RECEIVED
 CKB BY CLD OK'D BY GAS
 AUG 03 2007
 RESUBMIT APPROVED AS NOTED
 BY KMH DATE 8/13/07

BRIDGE No 37
 PROJECT No BRF 030-2(17)S
 ITEM No 621.74

FOR: F R LAFAYETTE, INCORPORATED
 VERMONT AGENCY OF TRANSPORTATION
 TOWN OF JOHNSON, COUNTY OF LAMOILLE
 BRIDGE RAILING FOR VT15 (MINOR ARTERIAL) OVER GHON RIVER
 3L ALUMINUM APPROACH ~ SPLICE DETAILS

MADE CMS DATE 05/29/07 JOB No AR0395 CUST No
 CHECK BLJ DATE 06/01/07 DRAWING LB15 REV. No. ONE

BARRIER RAIL SPLICES				
MK.	X	QTY.	OFFSET	LOCATION
SS-03-H3	1/8"	1	1/8"	SE APPROACH
SS-03-H4	1/16"	1	1/16"	SE APPROACH

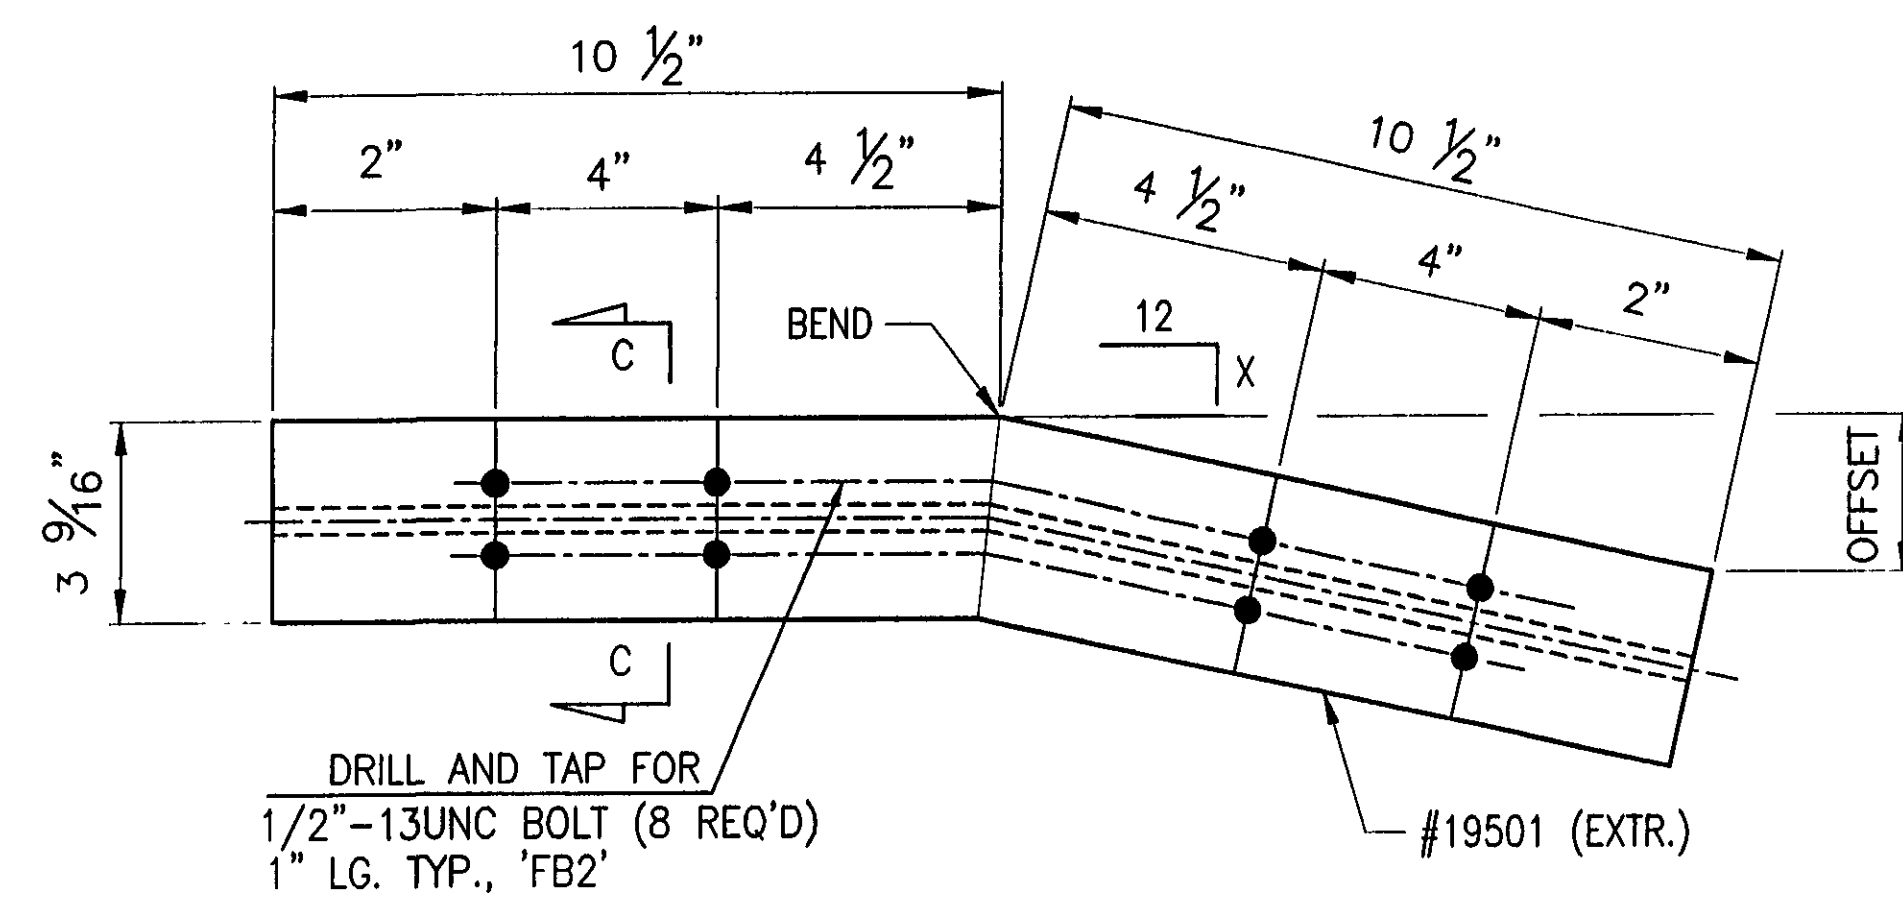
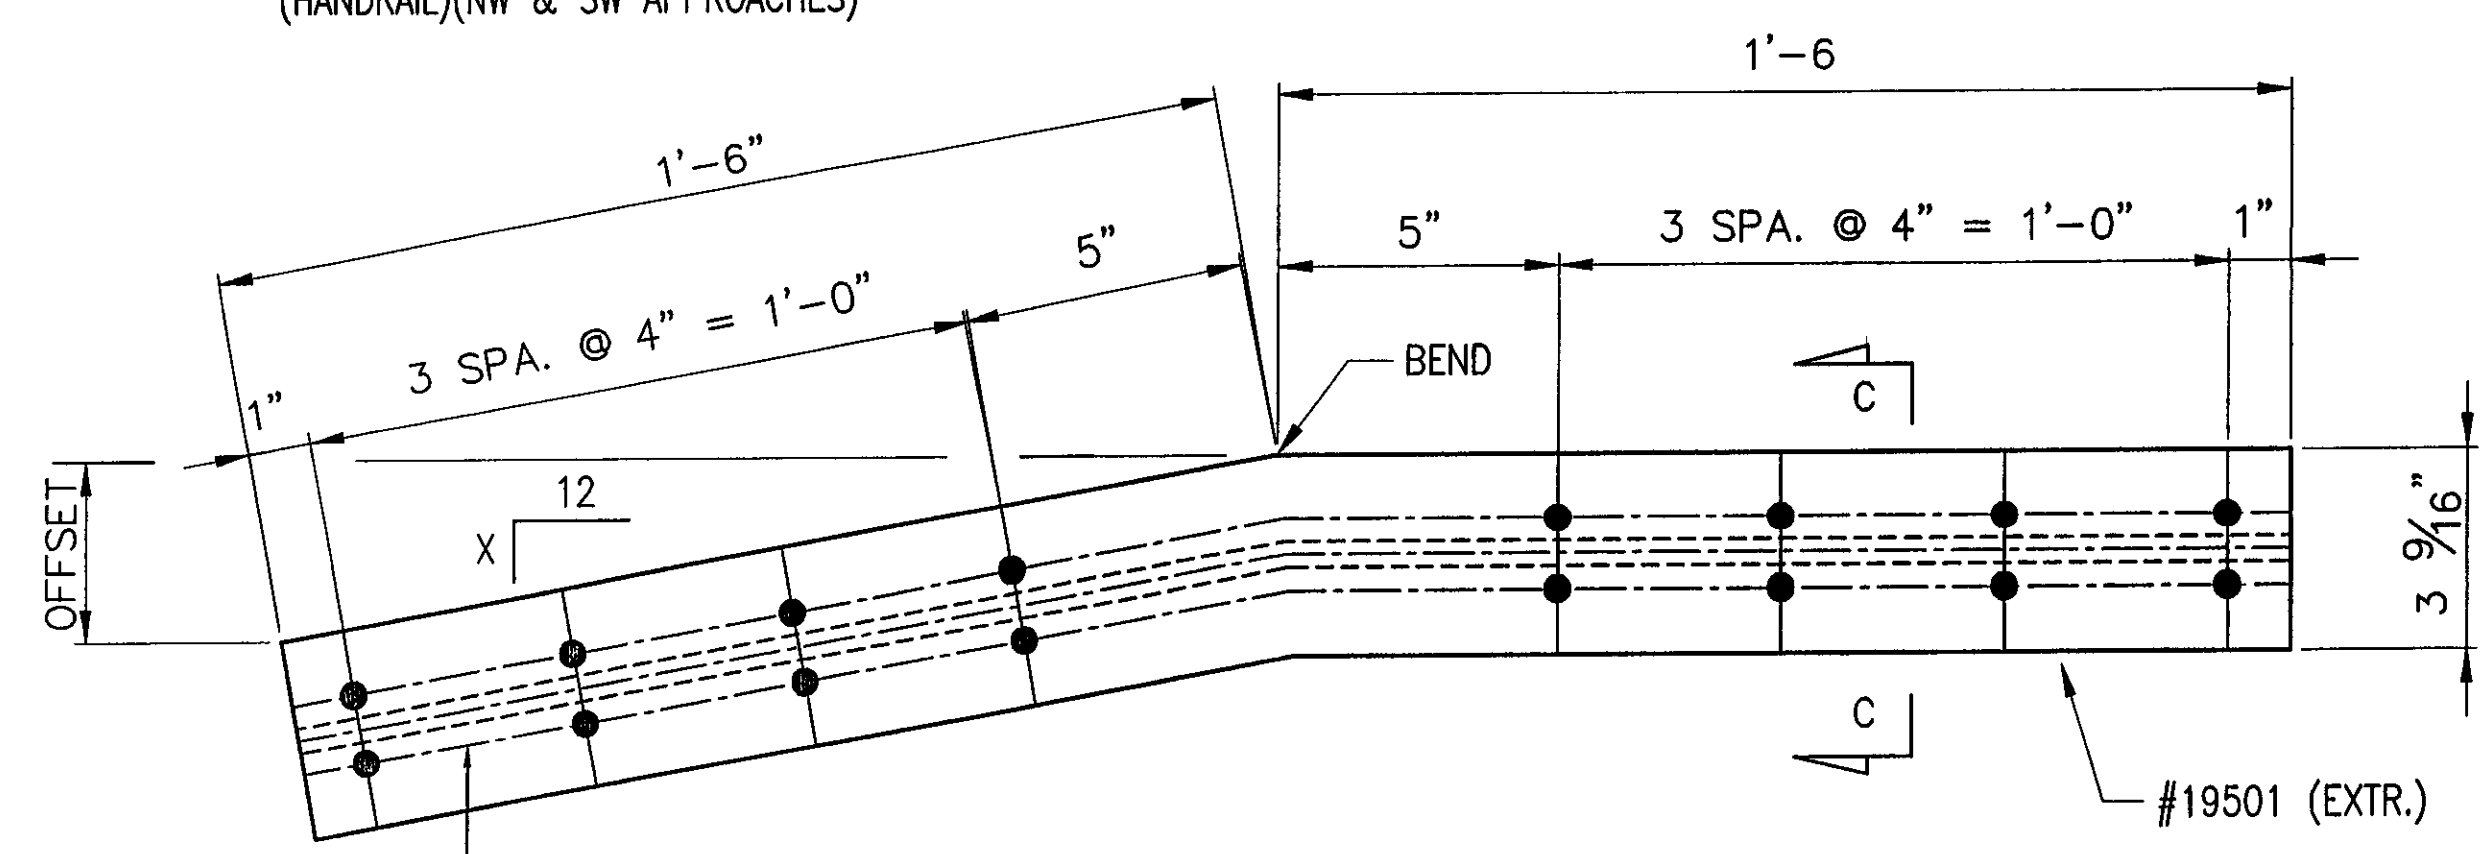
REV	DESCRIPTION	BY	DATE
1	REVISED DIMENSIONS PER APPROVERS MARKUPS	CMS	07/24/07
